The INDIAN Company

July 17, 1961

G2CS ALTERNATOR COIL CONVERSION

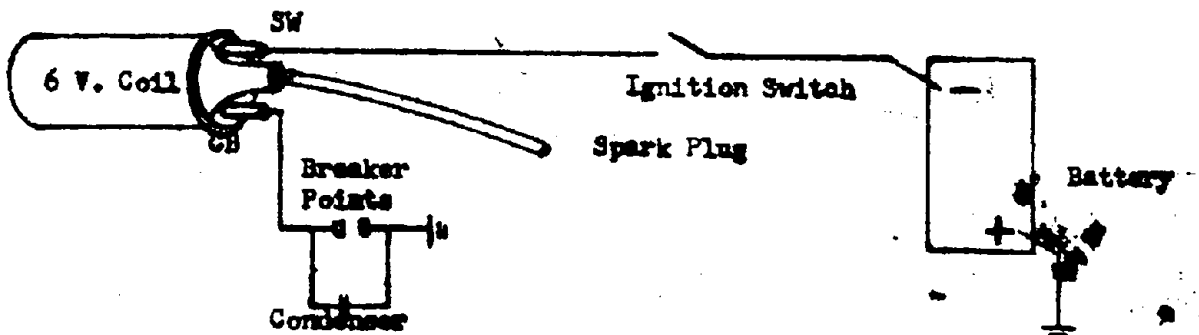
The enclosed sketch and sheet will explain the changes which have been made in the alternators and what has to be done to change the wiring on the motorcycle.

COIL CONNECTION

- 1
- 2
- 3
- 4
- 5
- 6
- 7
- 8

ORIGINAL COLOR

- Translucent
- Maroon
- White
- Brown
- Red
- Ground
- Red
- Ground

CONNECT TO

- Red
- White
- White
- Red
- Red
- White
- Red
- White
